# TECHNICAL BULLETIN

## Revised Underscuttle – Revised Mounting Method – Installation Instructions

76-108

MODEL Sedan Range 1990 - 1992 MY

ILLUSTRATION 1

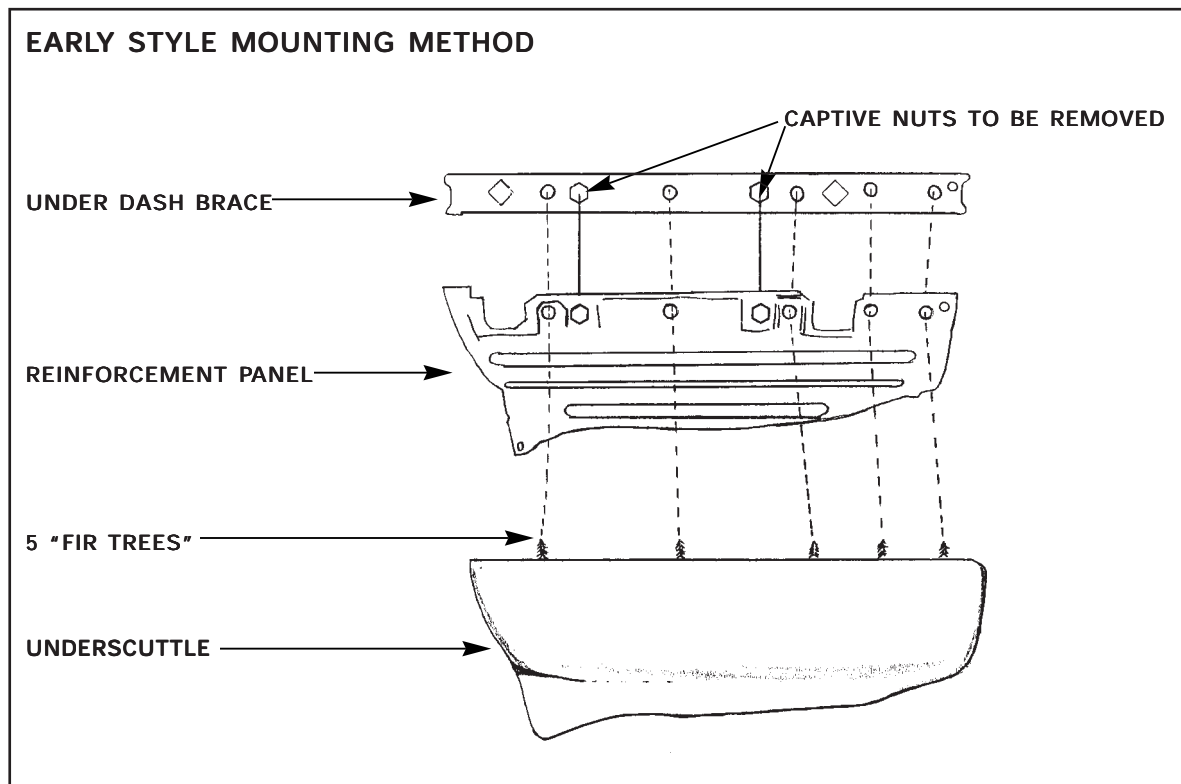
Replacement underscuttle panels have only 3 "fir tree" fasteners and do not fit directly in place of the previous panel with 5 "fir tree" fasteners.

1. After removing screws, use dash liner tool # JD 188 to remove the underscuttle from the vehicle.
2. Remove the reinforcement panel.
3. Remove and discard the two captive nuts indicated in Illustration 1.

ILLUSTRATION 2

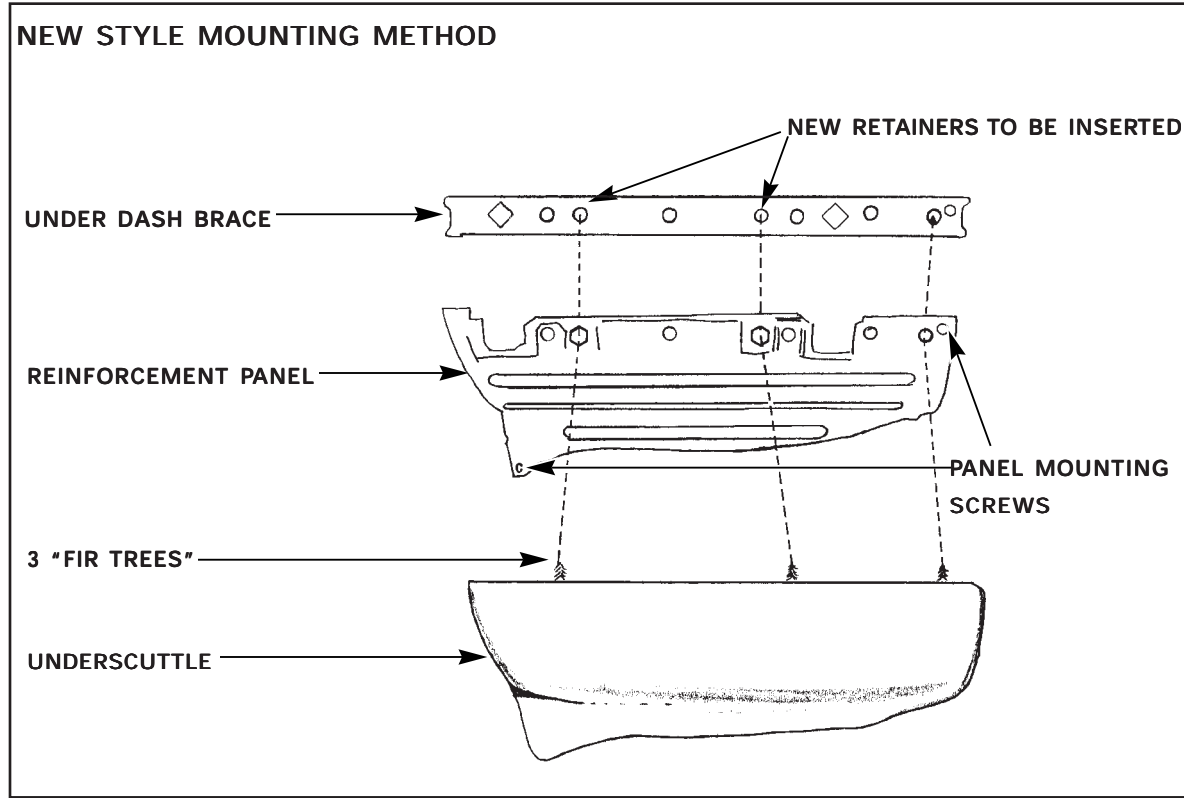
4. Insert the two new female fir tree retainers (AGU 2522/J) in place of the two captive nuts on the brace as indicated in Illustration 2. (Replace the third female fir tree retainer, if necessary)
5. Secure the reinforcement panel onto under-dash brace using the remaining screws at the lower left and upper right, Illustration 2.
6. Secure the new underscuttle panel (BEC 23962/\*) to the vehicle.
